## **Council-In-Committee Meeting – November 09, 2021**

Subject: Gilbert Road Culvert - Budget Amendment  
Report Number: EIS 21-06  
Division: Environmental and Infrastructure Services  
Department: Engineering  
Purpose: For Decision

**Subject:        Gilbert Road Culvert Replacement and its Impact on Hay Creek Dam**

Figure 1 - Existing Culvert on Gilbert Road as Modeled in DSR - 2.36m Span x 2.64m Rise Flood Depth

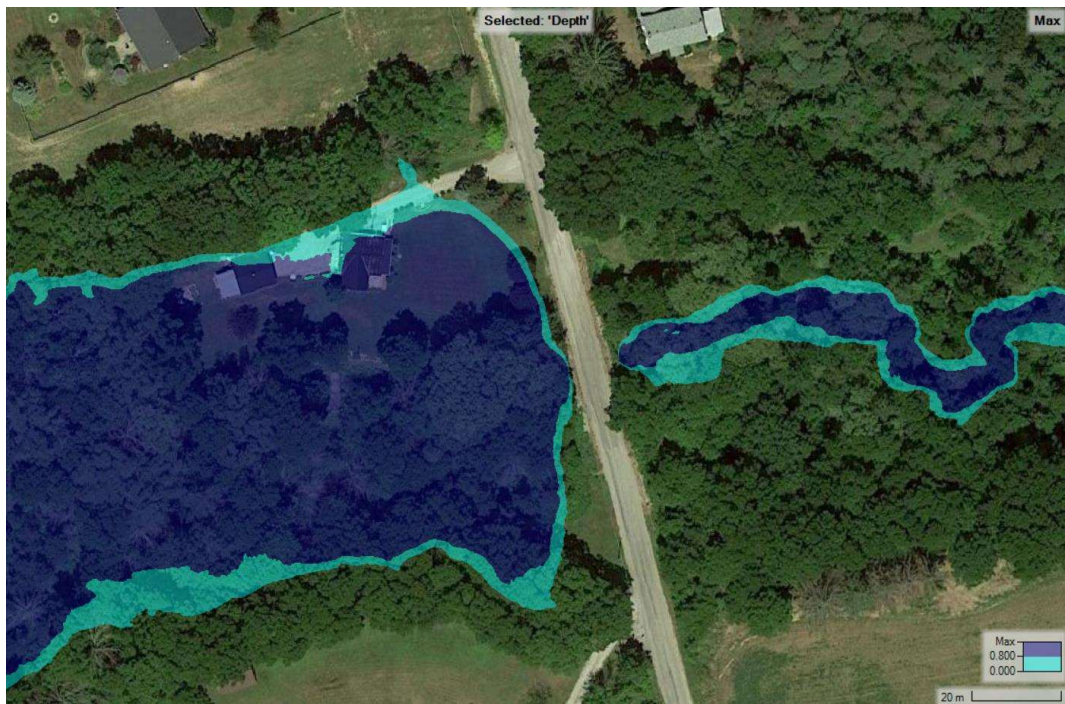
The existing Culvert as modeled in the DSR had a 2.36m span x 2.64m and upstream and downstream inverts of 193.4 m and 193 m respectively. The results of the flood flow dam breach model with the existing culvert at Gilbert Road can be seen below in Figure 1. Note that flood depths around the dwelling on the north upstream side of the culvert are greater than 0.8m.

Figure 2 - Two 3.96 m Span x 3.05 m Rise Box Culvert

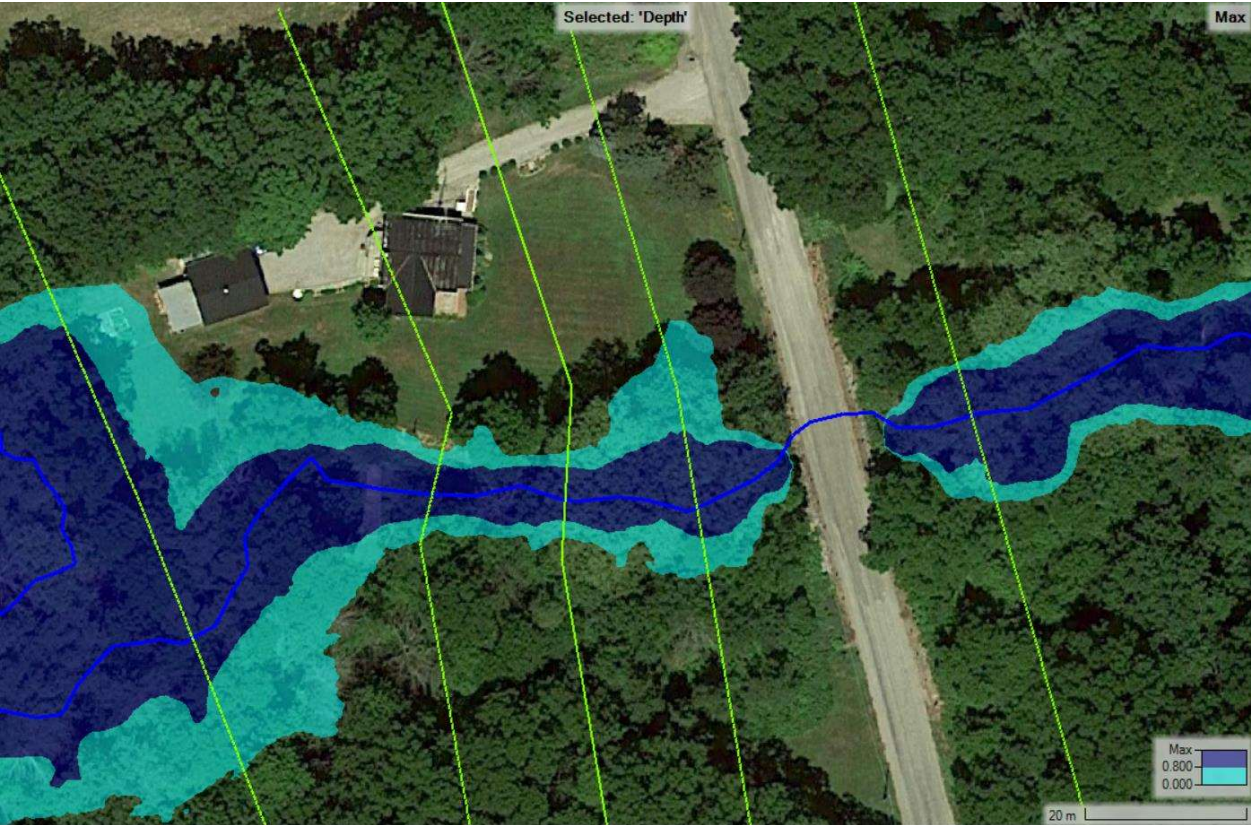
LPRCA staff found that two 3.96 m x 3.05 m box culverts using upstream and downstream inverts of 193.29 m and 192.89 m respectively were the smallest culvert configuration that completely removed the building from the floodplain. The results of the flood flow dam breach model with two 3.96 m x 3.05 m box culverts at Gilbert Road can be seen below in Figure 2. Note that there is no longer backwater at the culvert and the dwelling is completely removed from the floodplain.

It is LPRCA’s opinion that removal of culvert and road embankments or upgrading the existing culvert to a twin 3.96 m x 3.05 m box culvert configuration will lower Hay Creek Dam’s HPC from “High” to “Low” resulting in approximately \$700,000 in cost savings to Norfolk County from required dam upgrades.

Figure 3 - Two 3.65 m Span x 3.05 m Rise Box Culvert Flood Depth

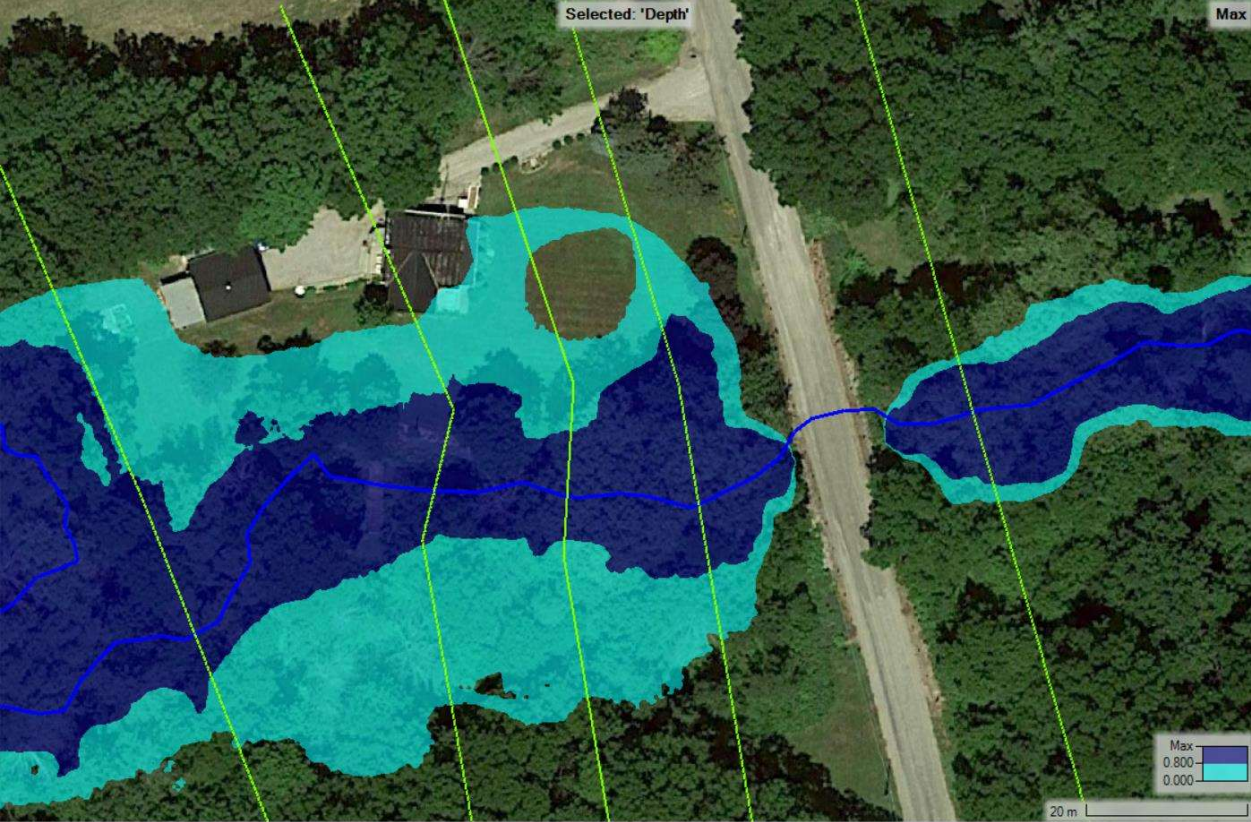
LPRCA staff’s analysis found that twin 3.65 m x 3.05 m box culverts using upstream and downstream inverts of 193.29 m and 192.89 m respectively would lower the HPC to “Moderate”. The results of the flood flow dam breach model with twin 3.65 m x 3.05 m box

culverts at Gilbert Road can be seen below in Figure 3. Note that there is still backwater at the culvert and the dwelling is still inundated; however flood depths do not exceed 0.8 m around the dwelling. The flow velocities also fall below the 2x2 rule and velocity thresholds for risk to life with this culvert configuration.

After review of the requirements of a “Moderate” inflow design flood in the MNRF Dam guidelines, LPRCA staff would expect that this would still trigger the need for a capacity upgrade at the dam. Therefore, there would be negligible cost savings going from a “High” HPC to a “Moderate” HPC.
